No. 86-32

Transmission Foaming/ Venting/Over Heating Borg-Warner In-Line Transmissions With 1.91:1 Reduction Units

Figure 1. Remarking Transmission Dipstick Measure From Inside of Dipstick Cover

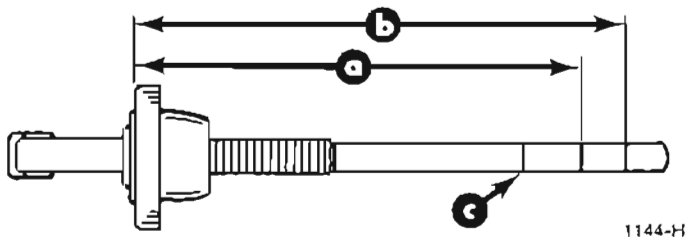
1. Remark the transmission dipstick.
 - A. Measure down from the inside of the dipstick cover the distance shown and mark two new points on the dipstick. (Figure 1) Using a suitable tool, a hacksaw blade works well, scribe a line across the dipstick at these two points.
 - B. Remove original full mark on dipstick using a file.

- a - 3-13/16" (97mm)
- b - 4-3/16" (106mm)
- c - Original Full Mark (Remove with File)

- D. Fluid level should be between the two marks on the dipstick. (Figure 1) If not, add or remove fluid as required to adjust fluid between marks. Repeat above procedure to double check fluid level.
